**AMENDMENT NO. 3**

**February 10, 2016**

The following summarizes revisions or clarifications to VA Solicitation No. VA101-15-R-0081 issued January 25, 2016. Drawings or Specifications referenced and included herein shall replace and supersede only the corresponding documents previously issued. All other documents not changed, replaced, or retracted by this or any subsequent amendment, remain a part of the solicitation. Offerors' proposals shall acknowledge Offerors' receipt and inclusion of this Amendment No. 3.

**Project Title**  
REHAB BUILDING

**4 TECHNOLOGY RISER DIAGRAM**  
NO SCALE

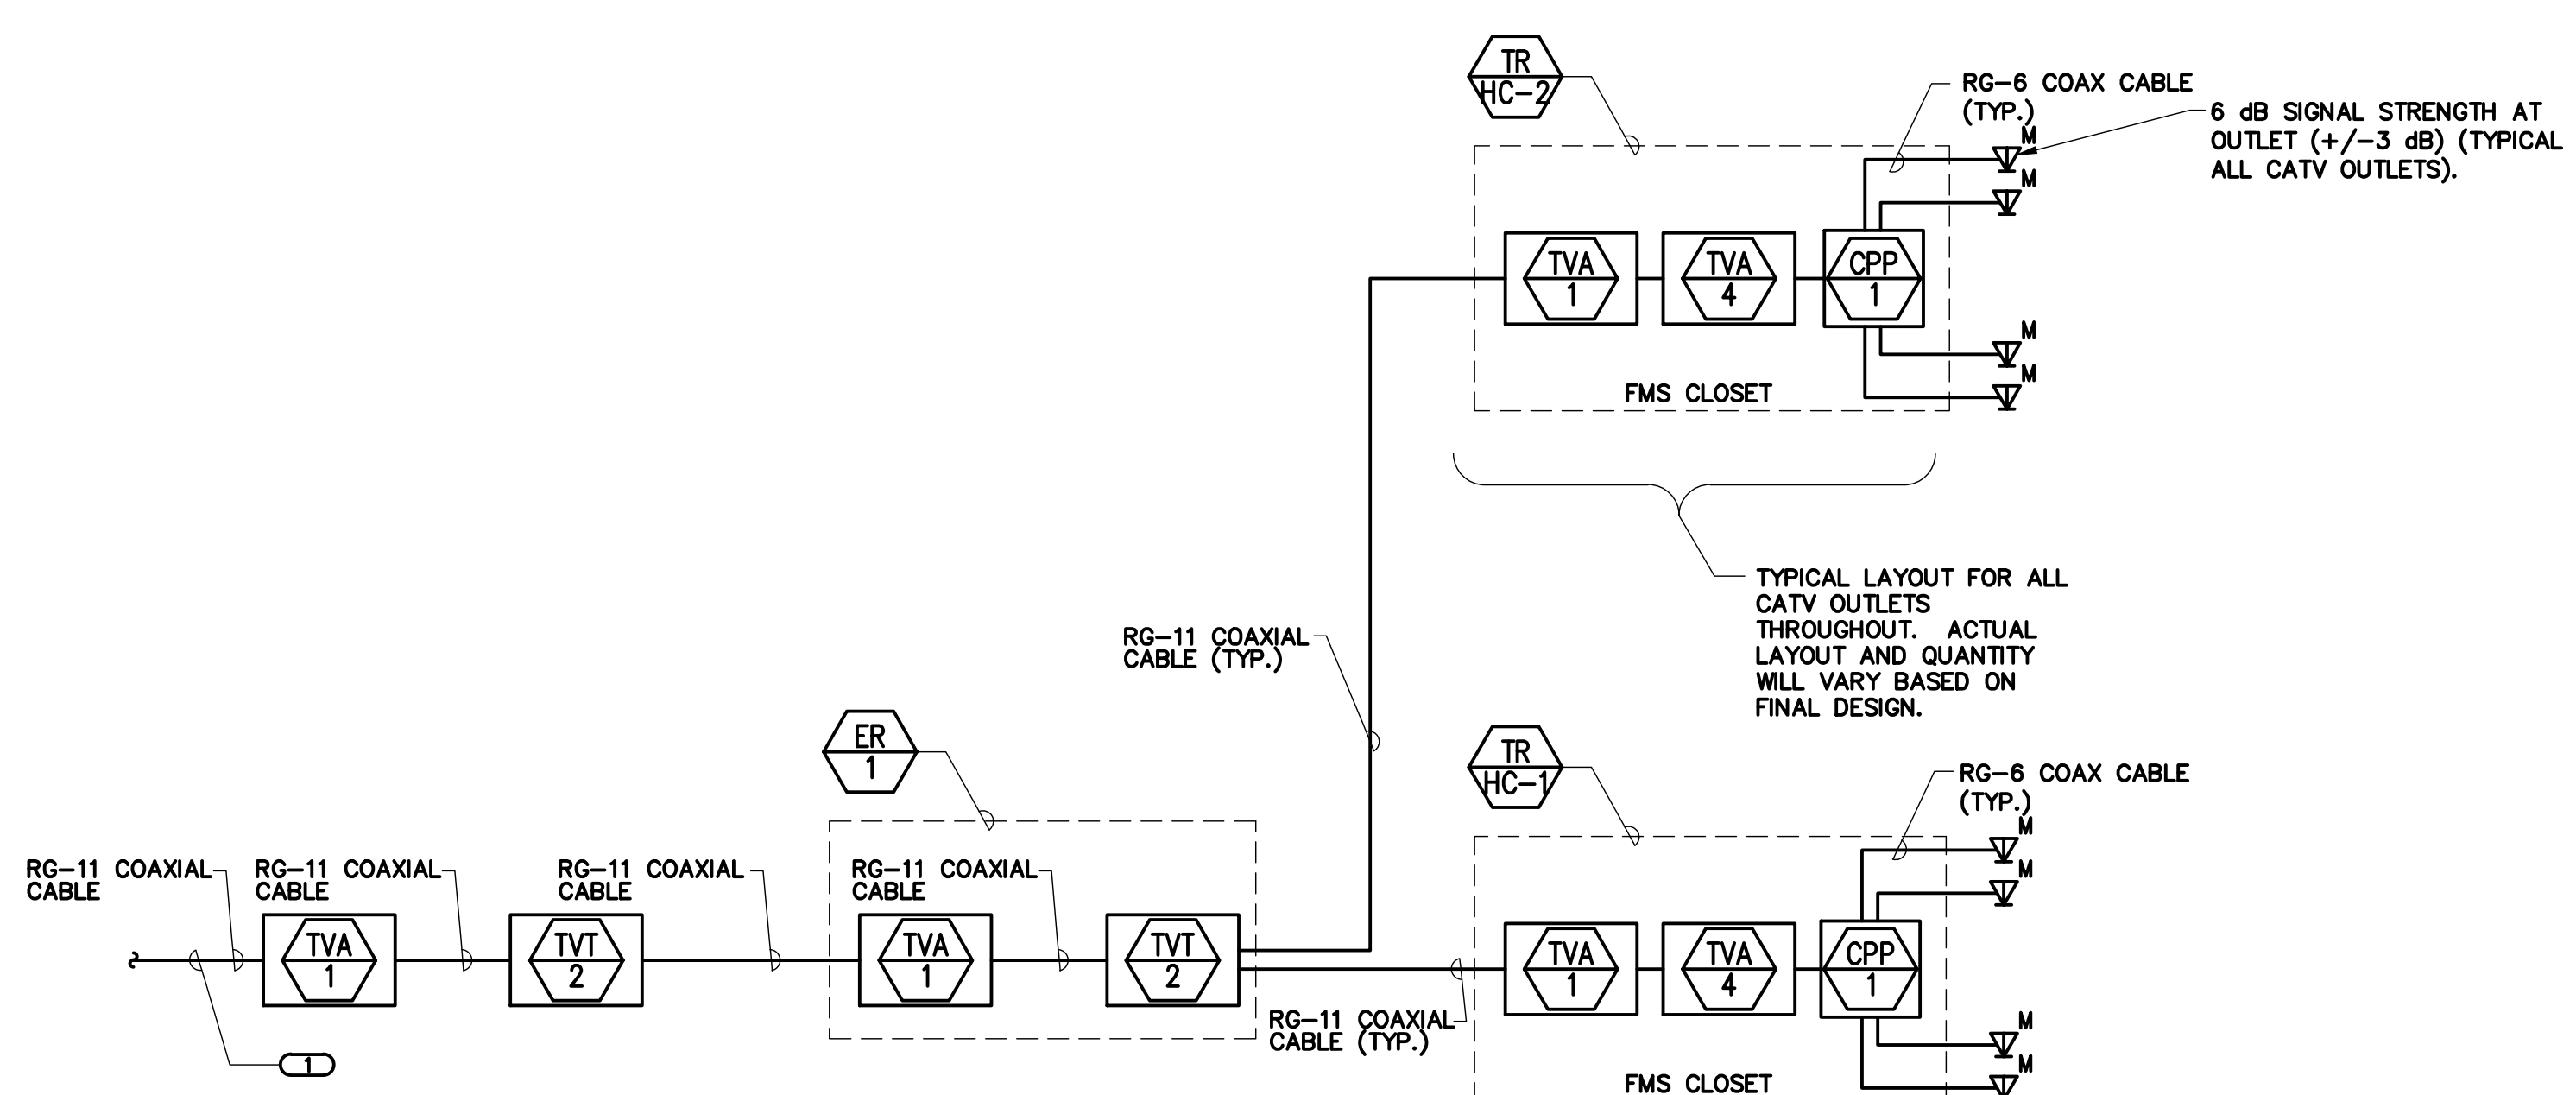
Sheet TN400:

- a. **REMOVE** 400 pair shielded twisted pair copper cable from Technology Riser Diagram.
- b. **REVISE** Keynote 7 to LC to LC fiber optic patch Cable.
